RECONSTRUCTION OF SMITH STREET (2026)
(HENDERSON STREET TO DAVID STREET)
AND
VICTORIA CRESCENT (2027)
(HENDERSON STREET TO SMITH STREET),
ELORA

Public Open House – Tuesday, December 16, 2025

PART 1 - Input from October 16, 2025

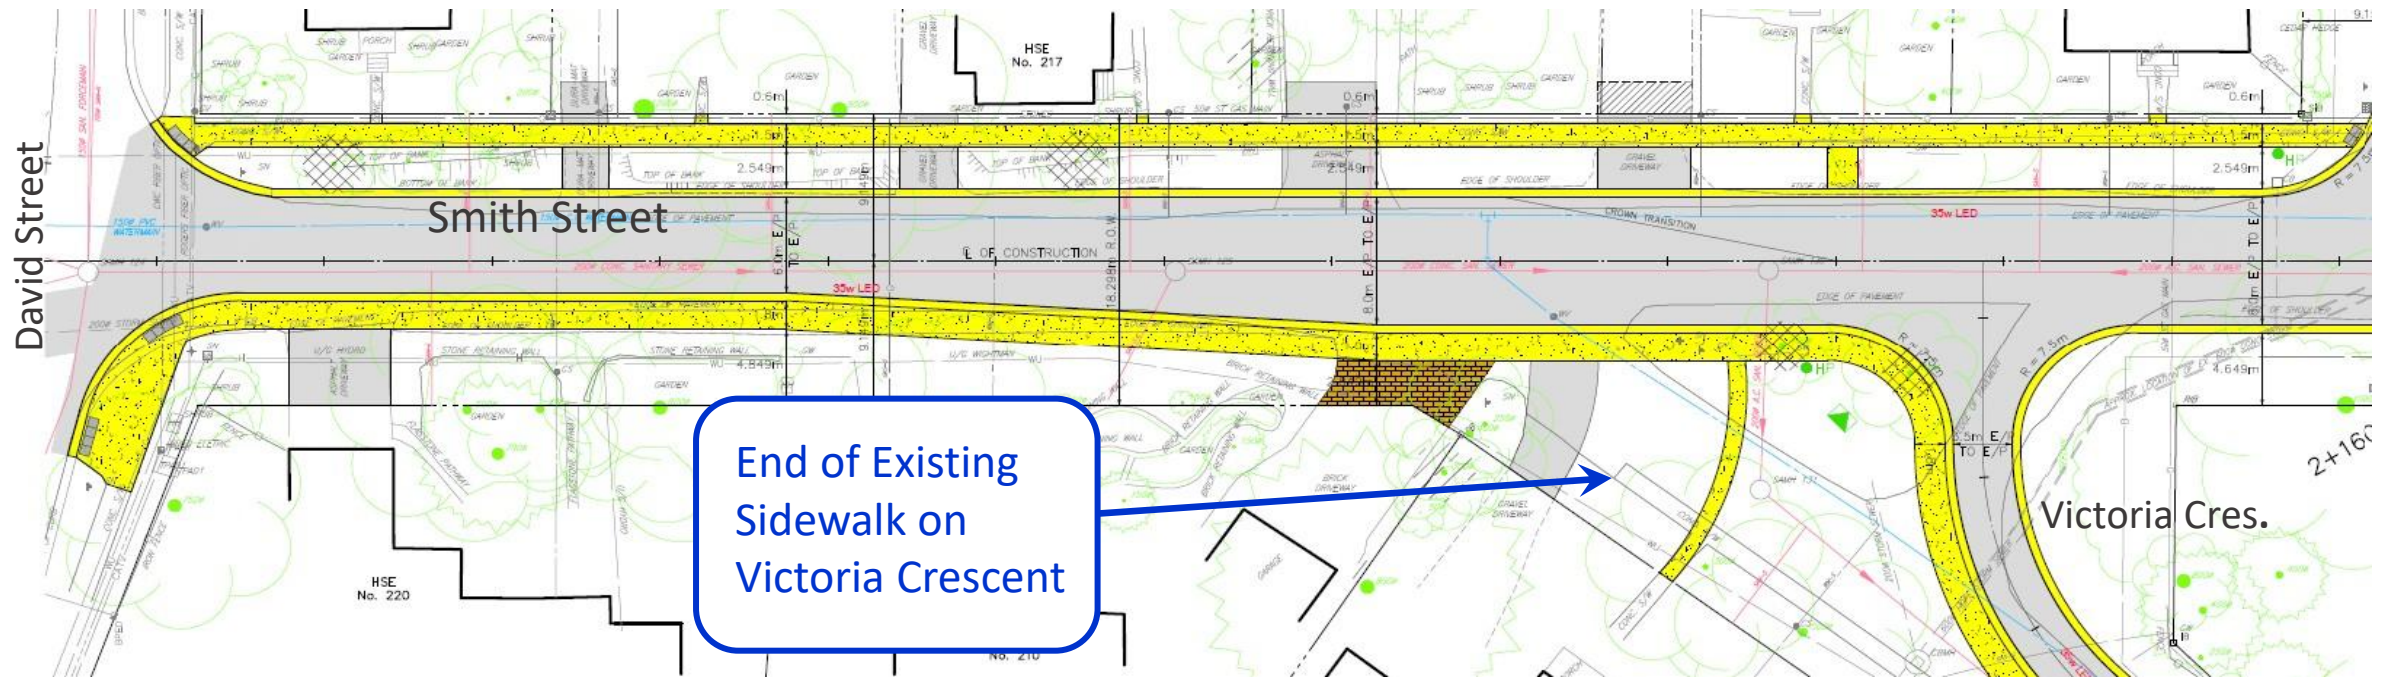
Comment: Consider pedestrians when planning project

Response: • Addition of sidewalk along the west side of Smith St. and Victoria Cres. completes the link between David St. and Victoria Cres., where the sidewalk previously ended mid block

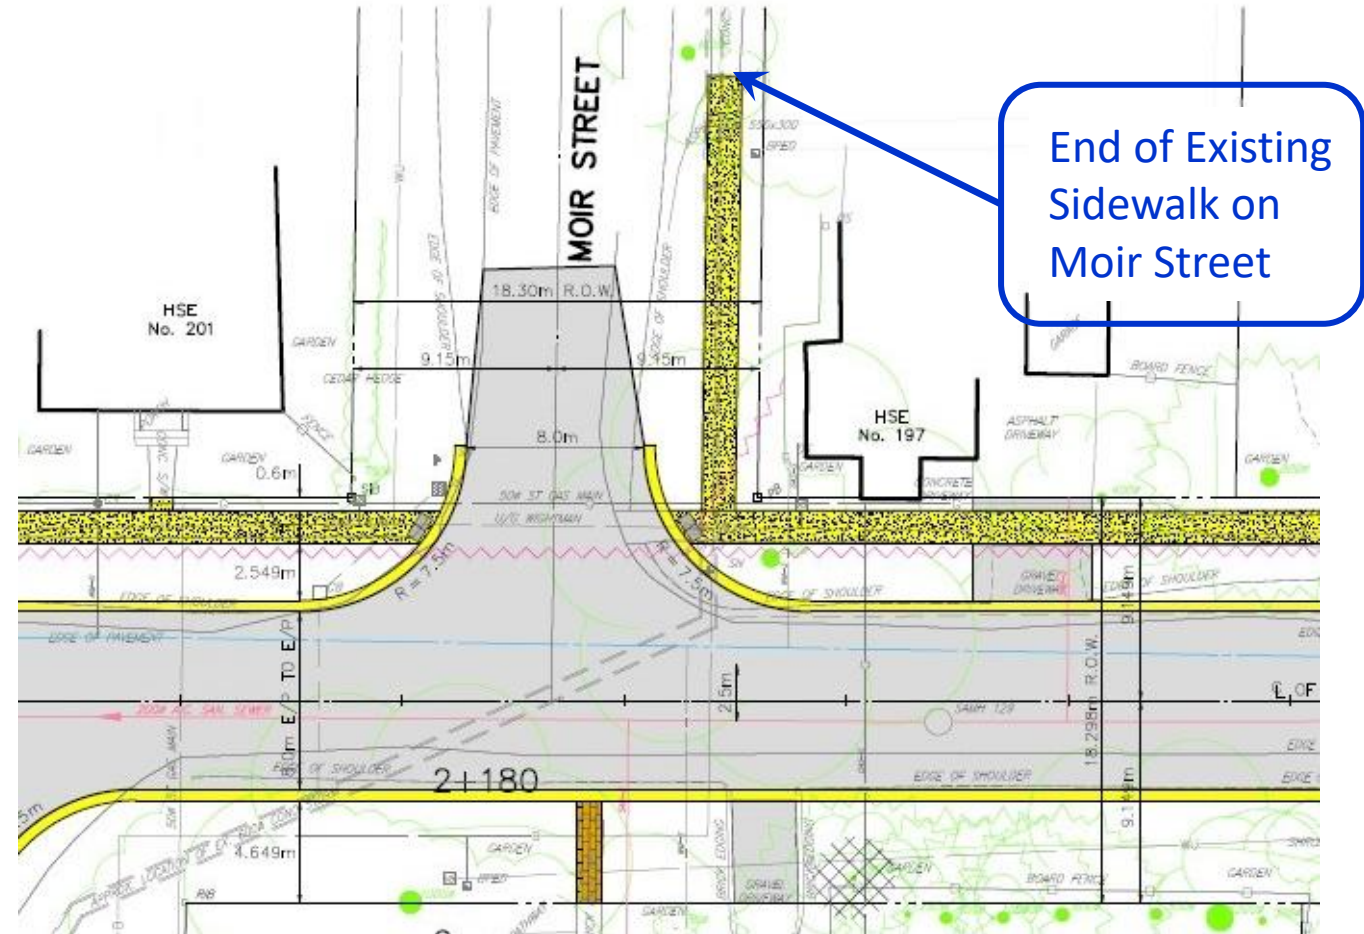
Comment: Consider pedestrians when planning project...cont'd

- Sidewalk extended east on Moir St. completing connection to existing sidewalk

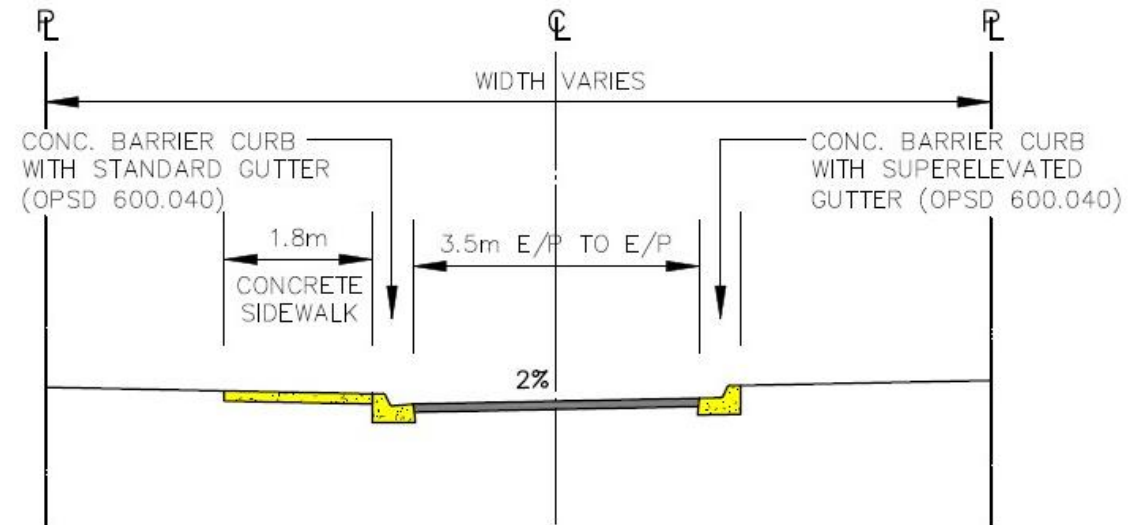
Comment: Sidewalk on west side of street seems unnecessary, except from “T-intersection” to Victoria Park.

- Sidewalk along the west side of Smith St. and connecting into Victoria Cres. was an identified route through our Active Transportation Master Plan.
- Adjustments made in the north portion of Smith St. to minimize or eliminate conflicts with the existing conditions.

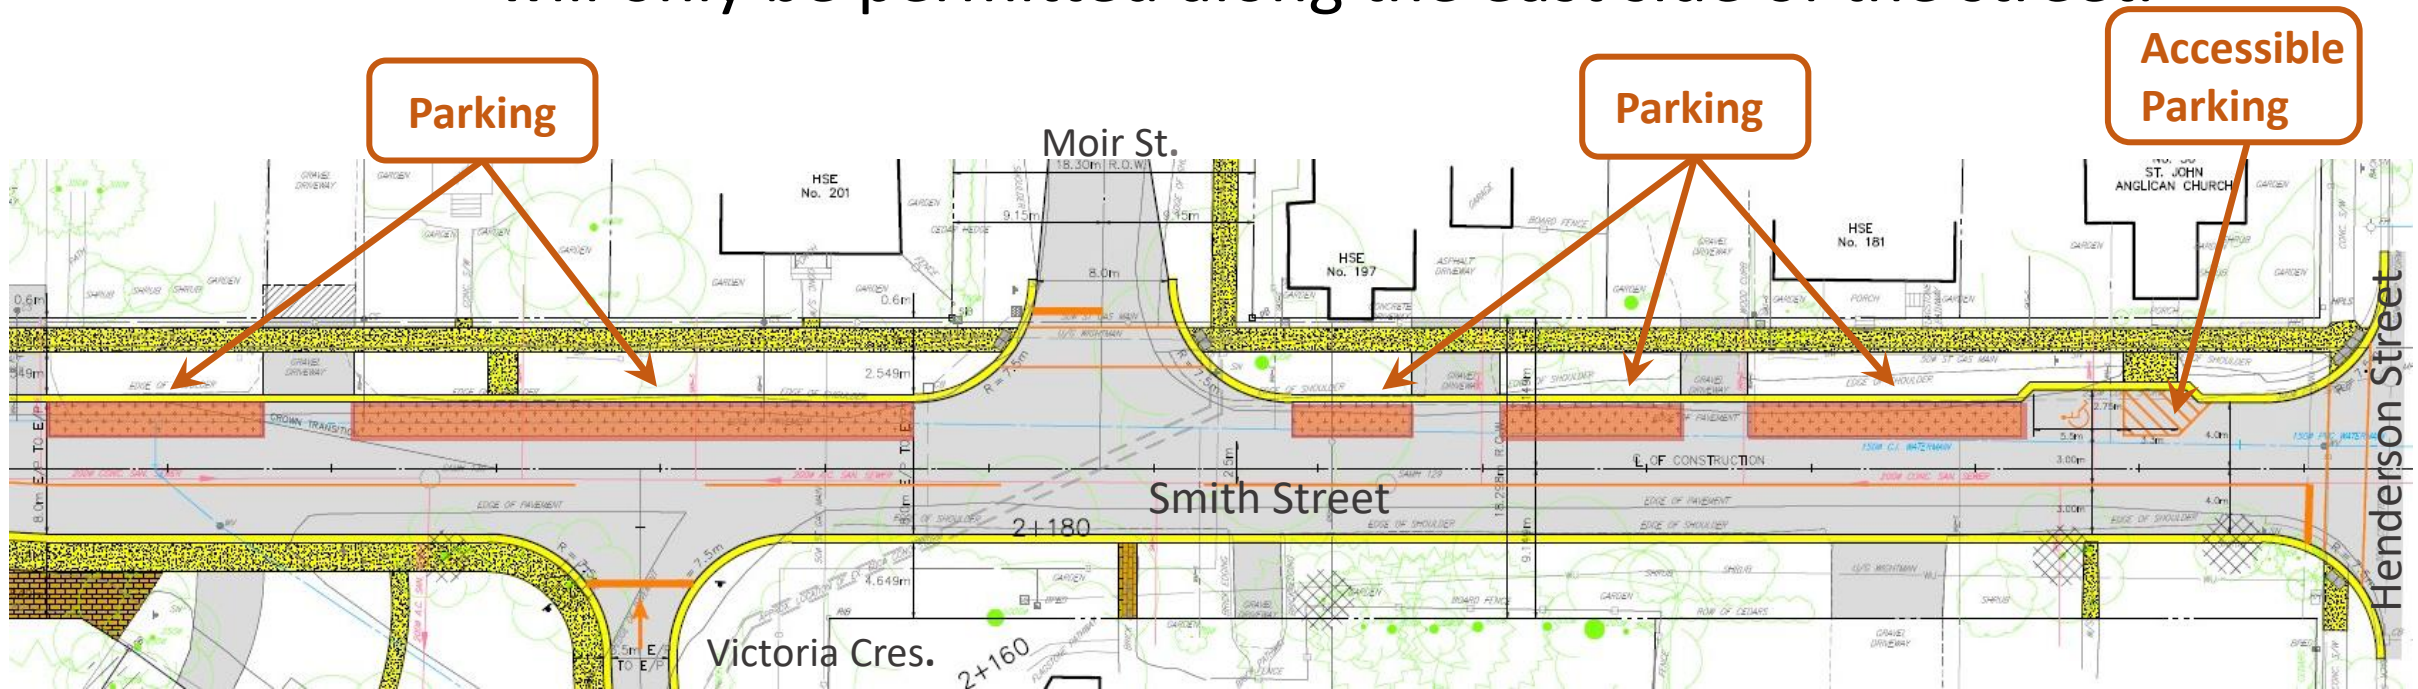
Comment: Parking should be on one side of Smith Street only

Response: • Agreed. Following the reconstruction of Smith Street, parking will only be permitted along the east side of the street.

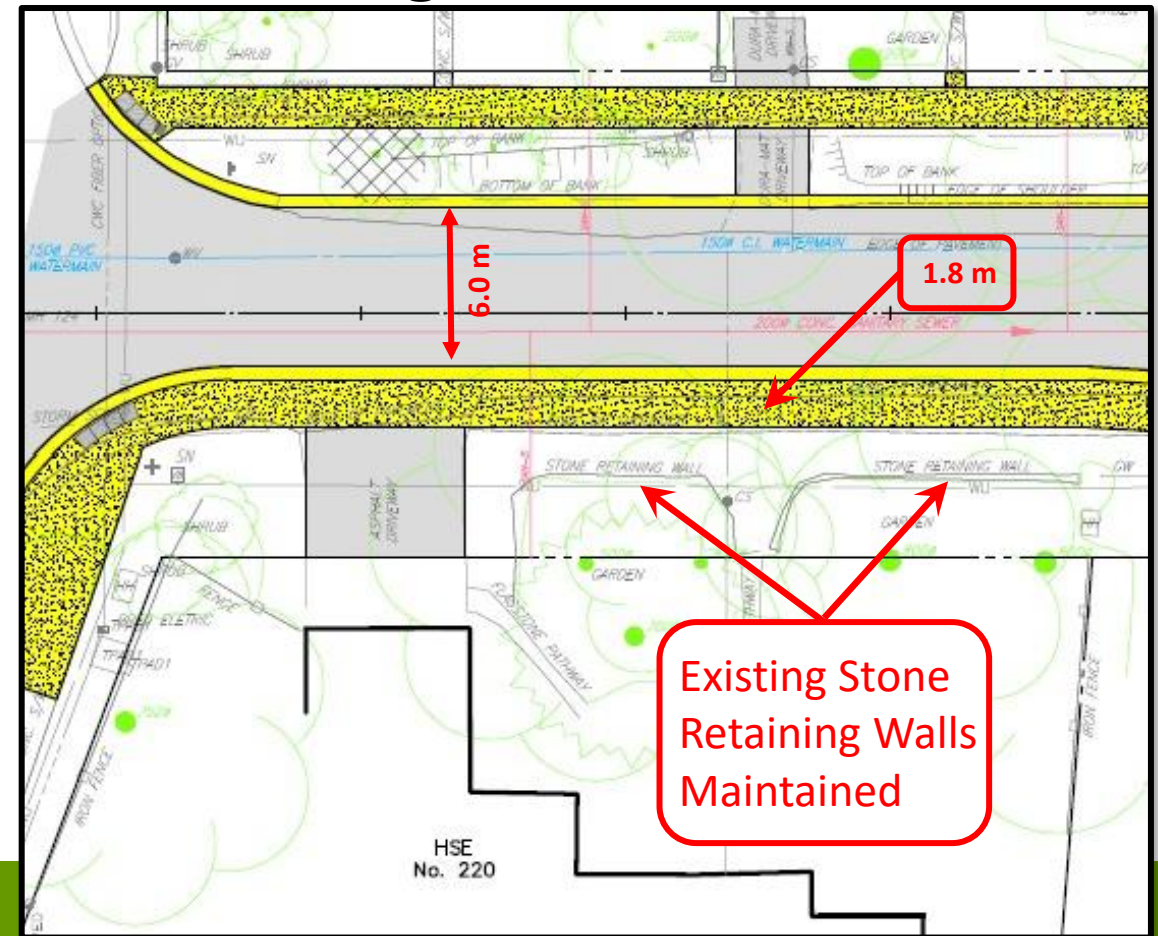
Comment: Save the Beech tree on the island if at all possible

- During the background information process, the Township's Urban Forestry Coordinator completes a tree assessment in areas that are to be reconstructed. This assessment provides a current assessment of the trees health and provides insight into how a tree may react should construction activities be within close proximity.
- The American Beech Tree within the island received a "fair" condition sighting there is significant decay in the main stem.
- This tree is in conflict with sidewalk that is being installed to create links to David St. and Moir St. and would be a sight line issue for motorists coming from Victoria Cres. and turning onto Smith St.
- The Township continues our policy of replanting two trees for every tree removed (2:1 ratio) as a result of construction.

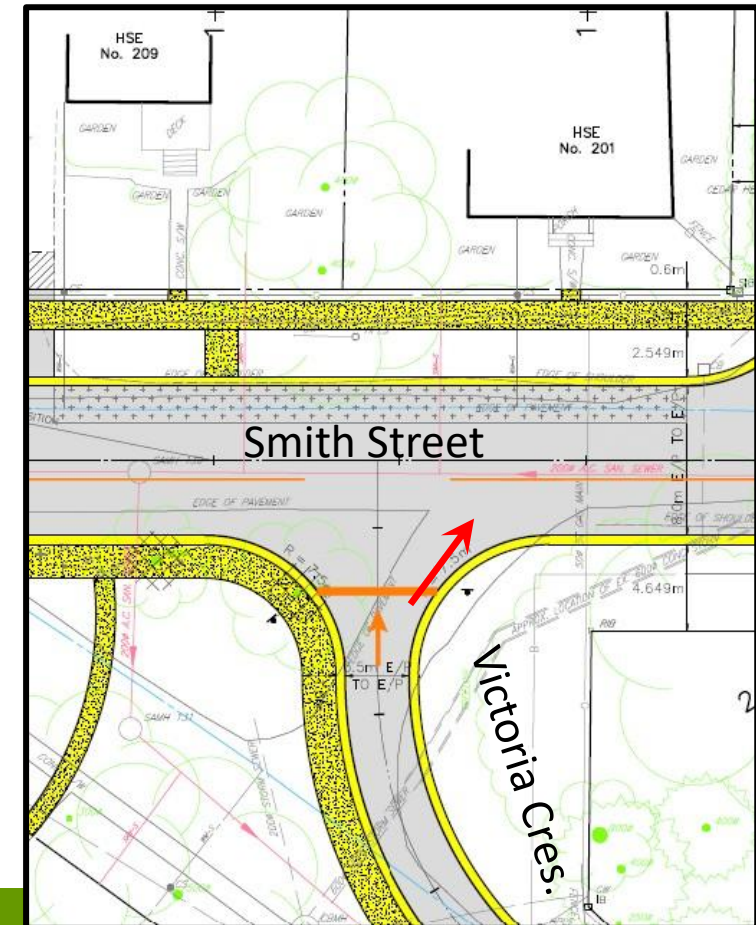
Comment: Concerned over the elimination of the triangle island and the impact of headlights shining from the T intersection into homes.

- Realignment for Victoria Cres. shifts intersection to the north. Therefore, aligning Victoria St. at a 90-degree angle to Smith St. (Orange arrow)
- The current alignment of Victoria Cres. less than 90-degrees, which currently aims headlights into a residence. (Red arrow)
